Date: Wednesday 6, Thursday 7 and Friday 8 November
2019
Time: 1:00pm (Wed), 9.30am (Thurs and Fri)
Meeting Room: Warkworth Town Hall
Venue: 21 Neville St, Warkworth 0910

**HEARING REPORT – VOLUME ONE
PRIVATE PLAN MODIFICATION 25 -
WARKWORTH NORTH
TURNSTONE CAPITAL LTD**

Figure 11: Indicative alignment of Western Link road (from Precinct Plan 1, PPC25)

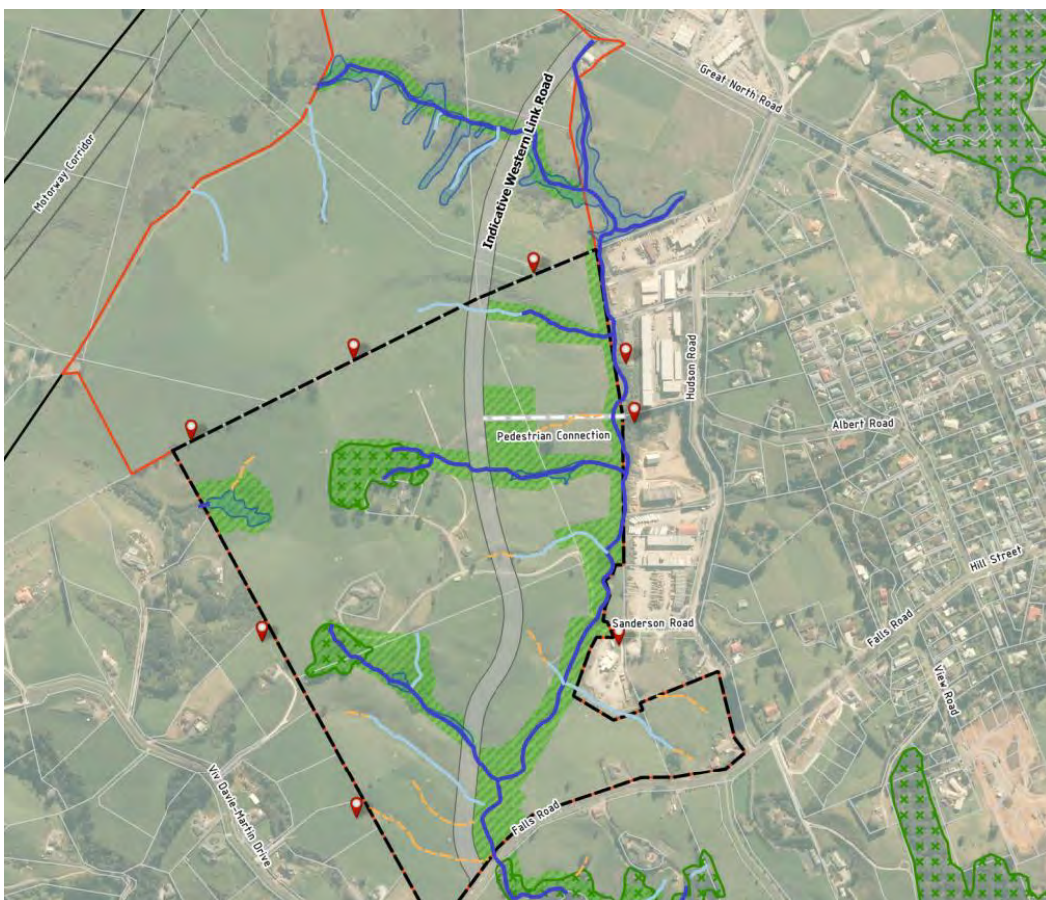
137. The s32 evaluation report notes that the Western Link road is a planned arterial road that is intended to alleviate traffic congestion within Warkworth by providing an alternative north-south route to State Highway 1. The road is intended to have limited access points, reinforcing its primary role as an arterial road that conveys traffic efficiently. Precinct Plan 1 from PPC25 illustrates the intended alignment of the “Indicative Western Link Road”, as shown in **Figure 11**, below.

Figure 12: Comparison of residential land identified in PPC25 (left) and WSP (right)

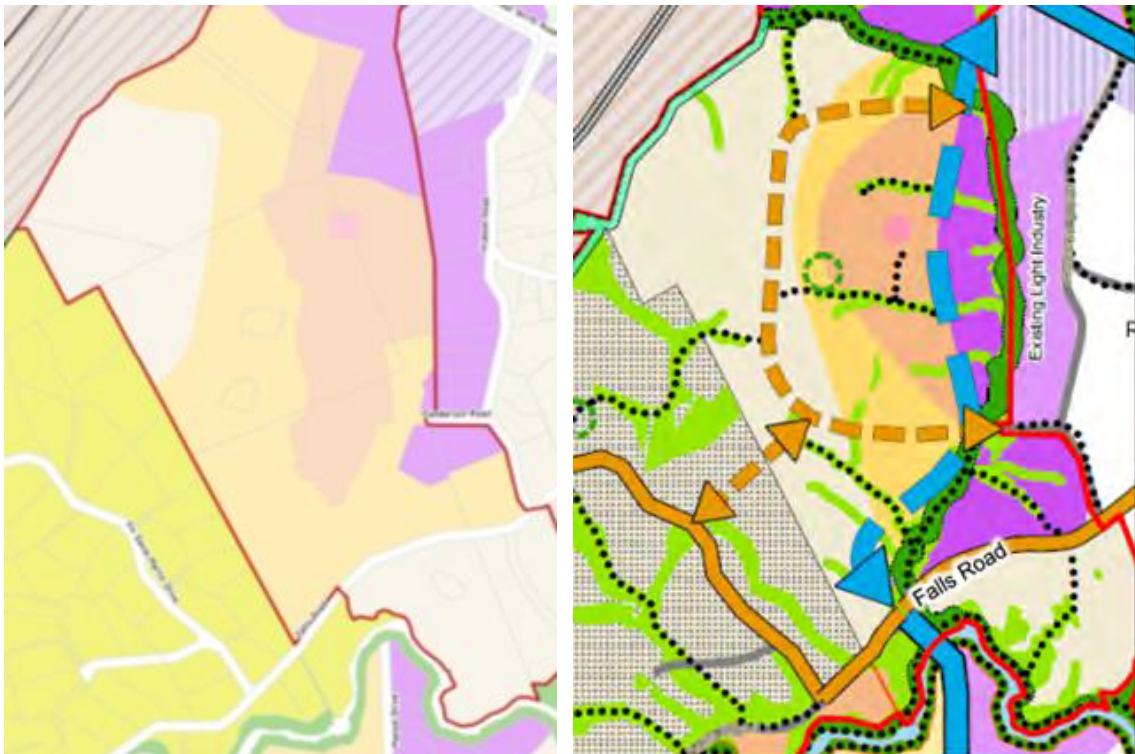
165. PPC25 provides for a different configuration of residential land to that identified under the WSP. This is illustrated in **Figure 12**, below. PPC25 proposes to maintain the Single House zone to the south of Falls Road, but contract it into the western corner of the land to the north of Falls Road. The Mixed Housing Urban zone expands slightly, but remains focused around the proposed Neighbourhood Centre zone. The Mixed Housing Suburban zone expands to replace the reduced Single House zone.

169. There are also disparities between PPC25 and the WSP in respect of the extent and location of the Light Industry zone. The differences are illustrated in **Figure 12** above. Having considered the available evidence and the WSP, I am of the opinion that some further industrial land should be provided by PPC25.

Figure 13: PPC25 Single House zone (left) and Stephen Brown's proposal (right)

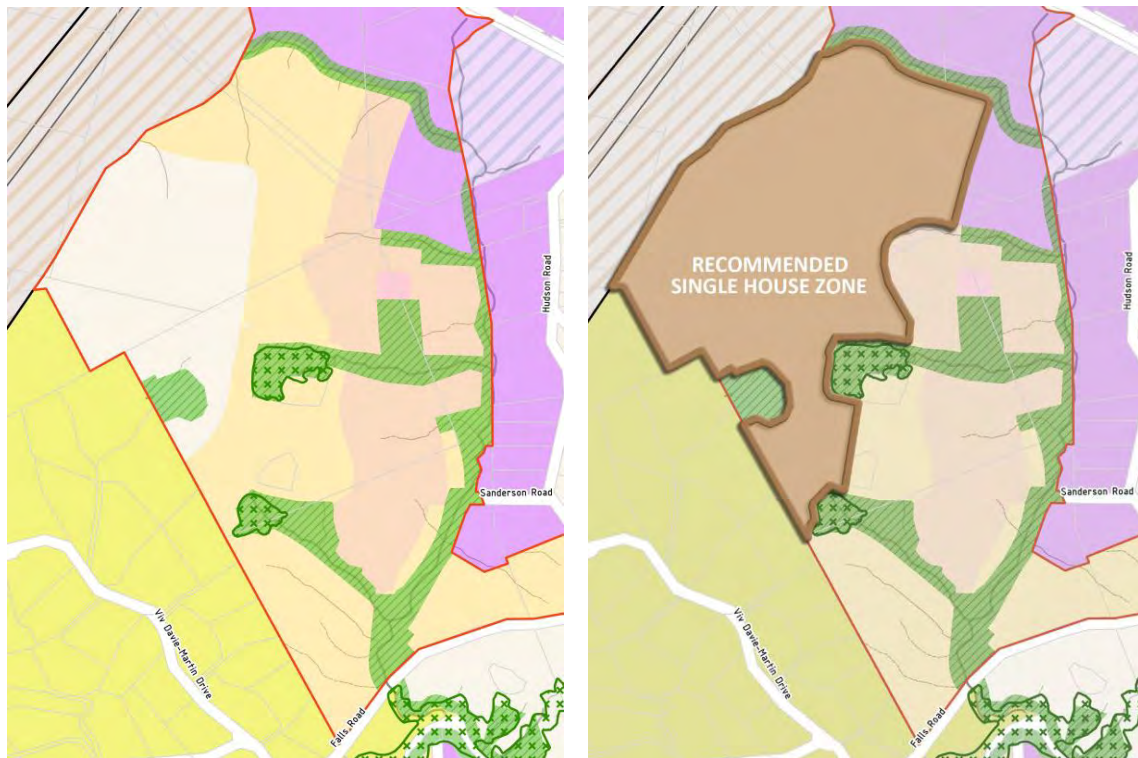
183. To address these reserve sensitivity effects, Mr Brown proposes a larger area of Single House zone relative to that proposed in PPC25. The extent of the Single House zone that he considers to be required is illustrated in **Figure 13** above.

187. The second contested landscape issue relates to the extent of Single House zone that should be retained in the north-western corner of the land. PPC25 proposes around approximately 12ha as shown in **Figure 13**. Mr Brown considers that this area should be roughly doubled to extend further down the slopes of the ridgeline and abut the Light Industry zone on the northern part of the PPC25 area.

Figure 2.1: Comparison of LIZ spatial extent: PPC25 (on left) vs WSP (on right)

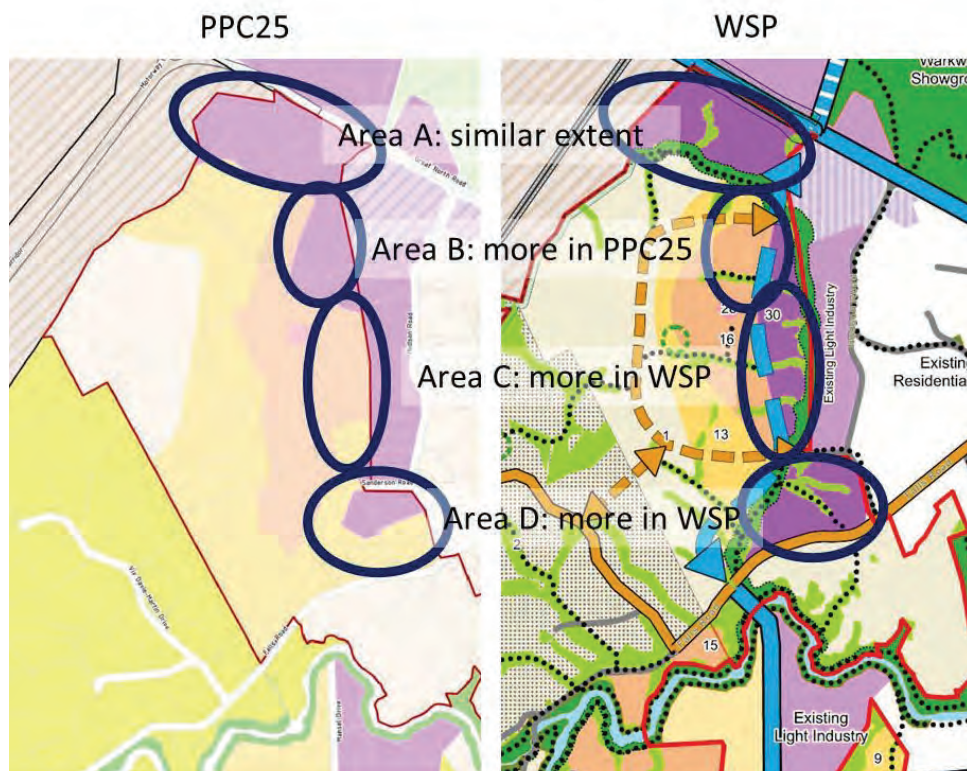
- The extent of the LIZ proposed varies between the two documents, as shown in Figure 2.1::
 - Area A: The WSP and PPC25 propose similar areas of LIZ bordering the current SH1, west of the live zoned General Business Zone.

- Area D: The WSP proposes a larger area of LIZ than PPC25. The former extends between Sanderson Rd and Falls Rd, whereas the latter extends only halfway between the two roads.

Figure 1: Approaches to zoning in PPC25 and the WSP

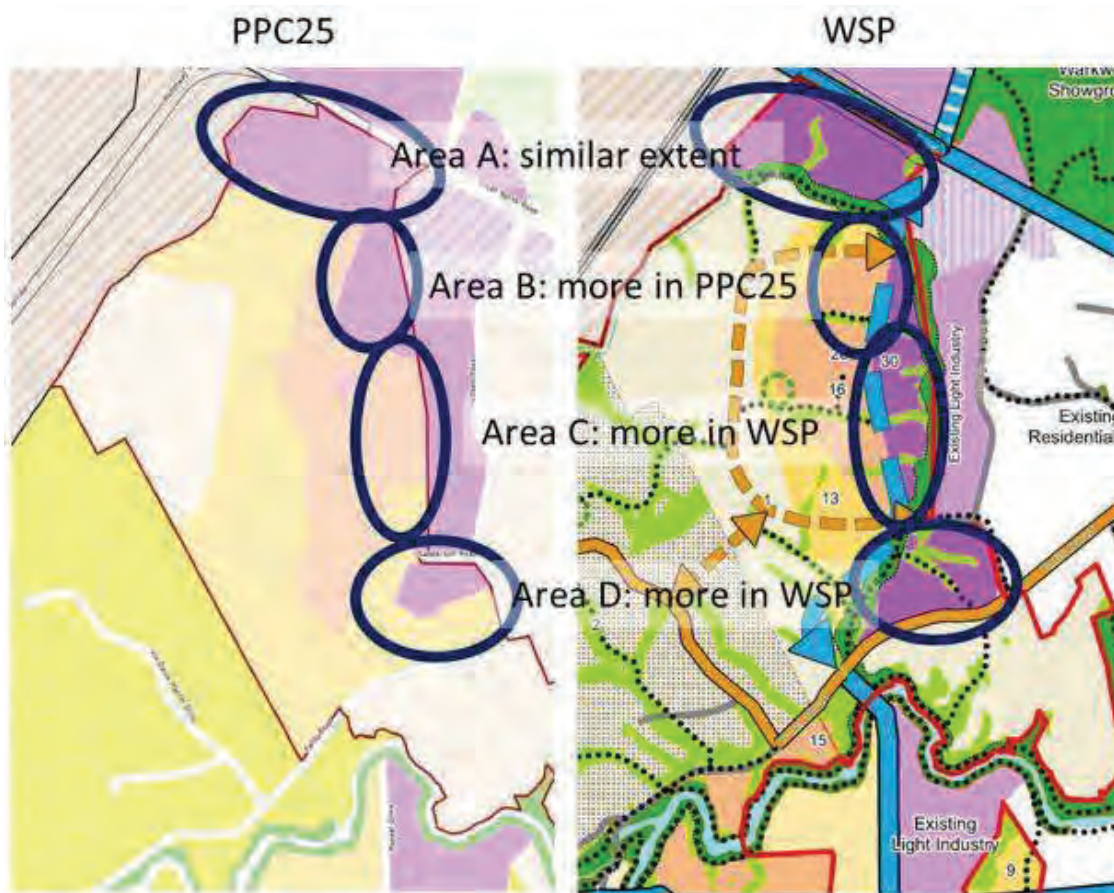
The zoning approach in PPC25, particularly the location of residential MHU and MHS as identified in Area C in figure 1, has failed to take into account the future alignment of the Western Link Road. The concern is that the residential zoning proposed in PPC25 is likely to give rise to an unconnected island of residential development between the eastern edge of the proposed road and the western side of the stream corridor.

One of the greatest degrees of variation between PPC25 and the WSP is in the proposed zoning adjoining the stream at the bottom of the valley, in the area identified as Area C on figure 1. The WSP identifies this area for LIZ as an extension to the Hudson Road industrial area as it is relatively flat land, within close proximity to the existing industrially zoned land. In contrast PPC25 proposed MHU zoning. In its submission to PPC25, the applicant proposes to amend this to Open Space – Informal Recreation (OSZ) adjoining the stream, an extensive area of Business – Local Centre (as discussed in section 4 of this memo) with MHU to the south of this.

The WSP identifies extension of the established Hudson Road industrial area south from Sanderson Road down to Falls Road (refer to Area D in figure 1). This is logical as a suitable location to provide for more potential employment land as it is connected to the existing LIZ zoned land, providing a considerable area of additional employment land. It should be noted that although the land is only zoned FUZ in the AUP, there are already light industrial type activities located on the two lots fronting the southern side of Sanderson Road in the form of the Warkworth Water Treatment Plant and a consented and established storage facility.
